**City of Portland, Maine – Building or Use Permit Application** 389 Congress Street, 04101, Tel: (207) 874-8703, FAX: 874-8716

BUILDING PERMIT REPORT

DATE: 20 Aug 99 ADDRESS: 1492 Washington Ave CBL: 347-C-049  
 REASON FOR PERMIT: Change of use From 3 dwelling units To 2 dwelling units  
 BUILDING OWNER: Fusco  
 PERMIT APPLICANT: Contractor SAO  
 USE GROUP R-3 CONSTRUCTION TYPE 5B

RE: 1492 Washington Avenue, Portland, ME. - 347-C-40 - R-3 zone

# 1st Floor

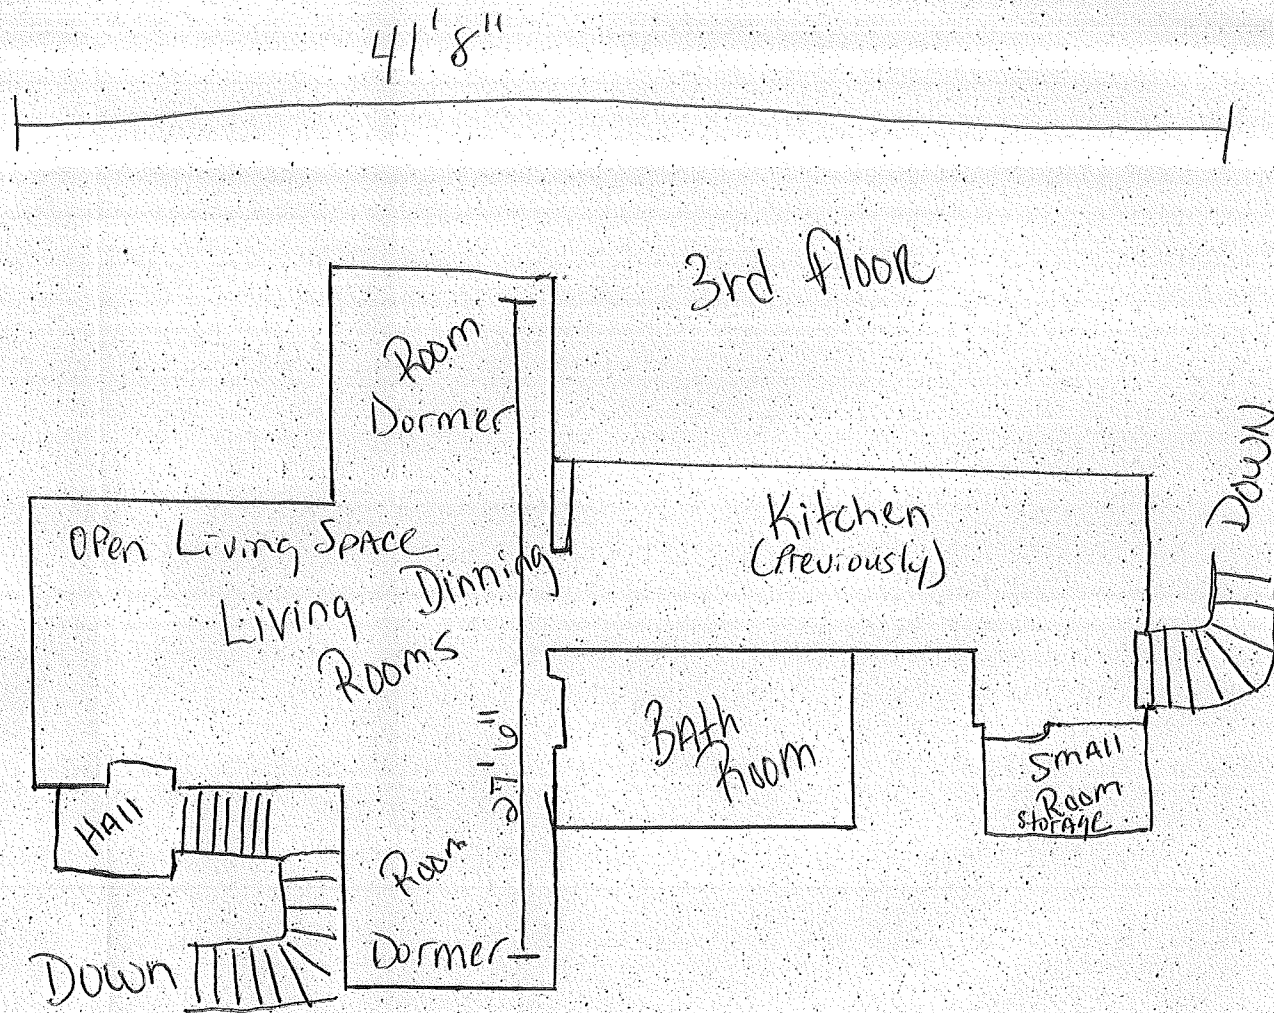
Note: The kitchen will be removed and the second and third floor will share the second floor kitchen. They will operate as one unit.
